Project Name | BCWD Permit 24-07, Elliott Crossing

Date | November 7, 2024

Regarding | Permit Application No. 24-07 Engineer's Report

Figure 5 - Irrigation Area (Pond 200)

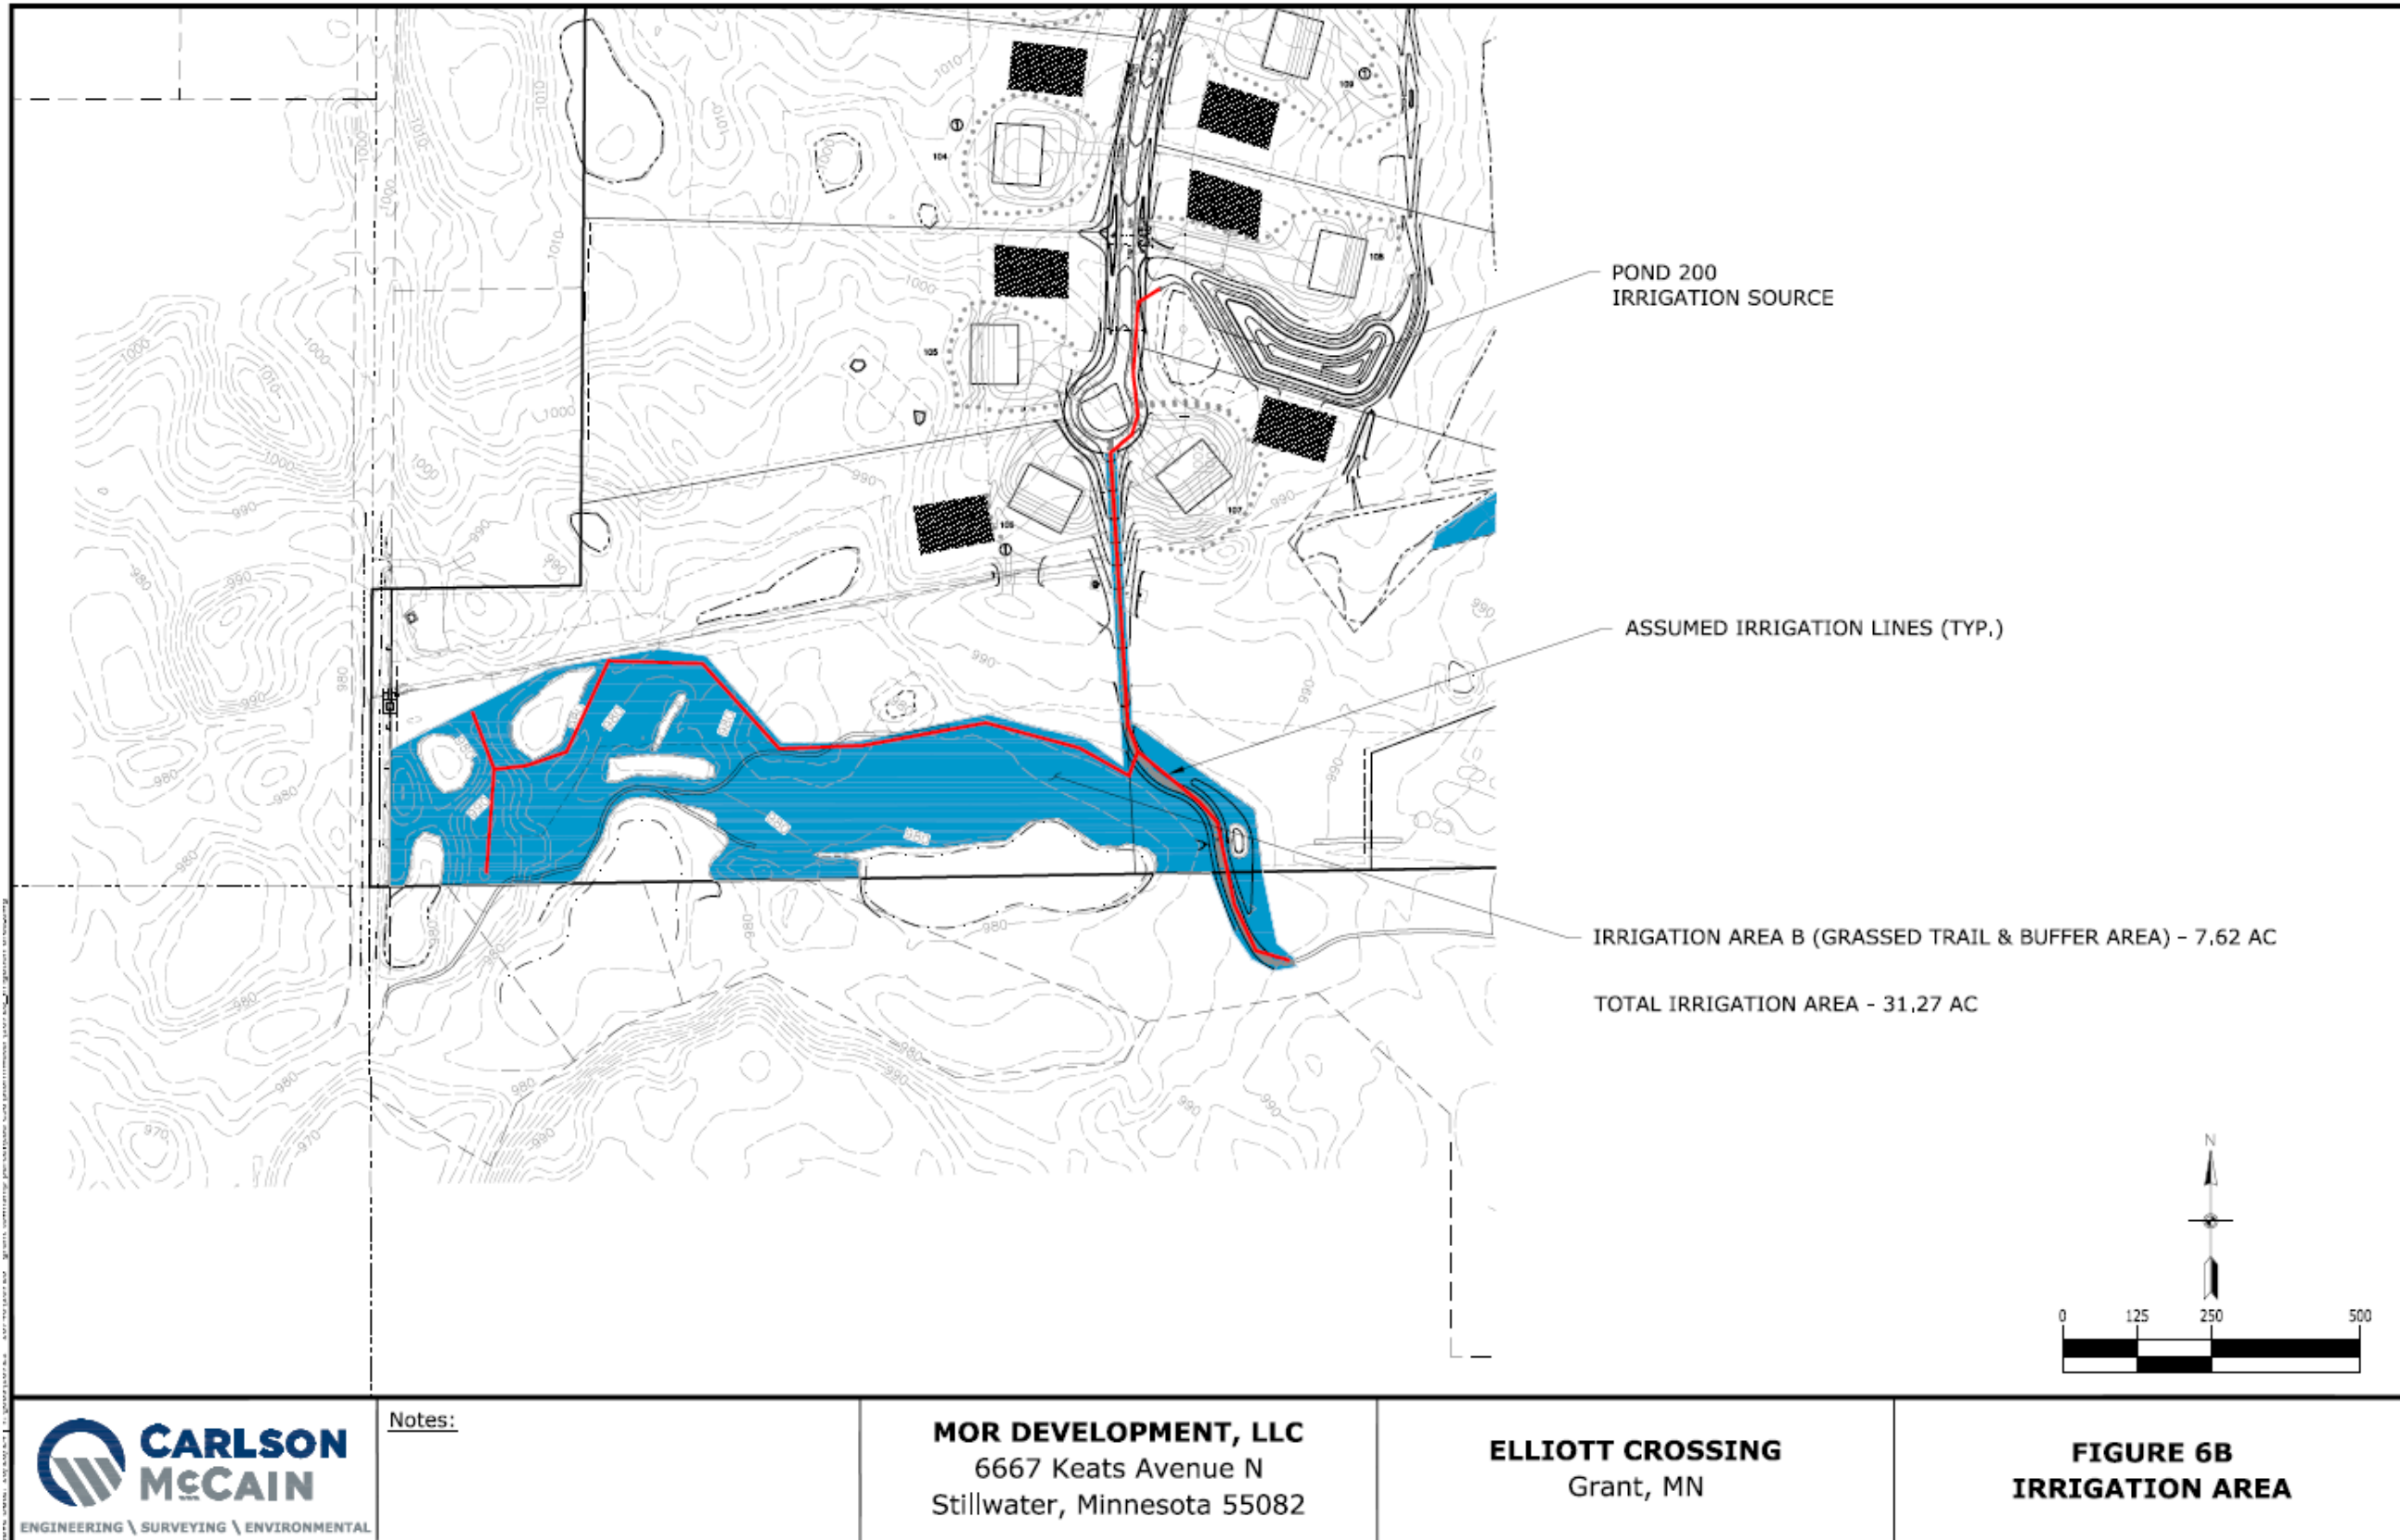
The two re-use ponds will provide stored stormwater to be used to irrigate a small, landscaped area at the site entrance along with the wetland buffers. Irrigation areas are shown in Figure 4 and Figure 5. Re-use Pond 300 will irrigate the buffer downstream (east) of the fen while Re-use Pond 200 will irrigate the buffers on the south side of the site around Wetlands M and N. The re-use ponds will be pumped down using an automated system. At an irrigation rate of 0.06 inches/hour (consistent with HSG D soils found in this portion of the site), both ponds can be drained within 48 hours to allow capacity for future storm events and for volume control analysis these ponds were assumed to start empty. The ponds are proposed to be drained at a lower rate to avoid saturation of the soil and runoff from irrigation. This would take longer than 48 hours to drain the ponds from full, depending on the pumping rate. This pumping rate is needed to confirm that the ponds will empty quickly enough to regain storage capacity between storms, such that the assumption of the ponds starting empty for volume control analysis is correct. Therefore, additional detail on the irrigation system is needed and will be required as a condition of permit approval. Specifically, the following must be provided:

- *Proposed pumping rate(s)*
- *Duration of time required to fully drain ponds*
- *Pond water levels that trigger pump operation*
- *Irrigation head velocity*

- 2-1. Provide BCWD with the final civil plan set (BCWD 2.7.9).
- 2-2. Provide the following information related to the stormwater irrigation system.
 - Proposed pumping rate(s)
 - Duration of time required to fully drain ponds

- Pond water levels that trigger pump operation
 - Irrigation head velocity
- 2-3. Provide a draft stormwater facility maintenance declaration for BCWD approval, then, after approval, provide proof of recordation with Washington County (BCWD 2.6). A template is available under the permit section of the District's website. The maintenance declaration must include the following:
- Protection of all vegetated areas that must be preserved for irrigation use on the property, and
 - Annual documentation of the volume of water used for irrigation along with the dates during which the irrigation system was active.
- 2-4. Provide documentation as to the status of a National Pollutant Discharge Elimination System stormwater permit for the project from the Minnesota Pollution Control Agency and provide the storm water pollution prevention plan (BCWD 2.7.15).
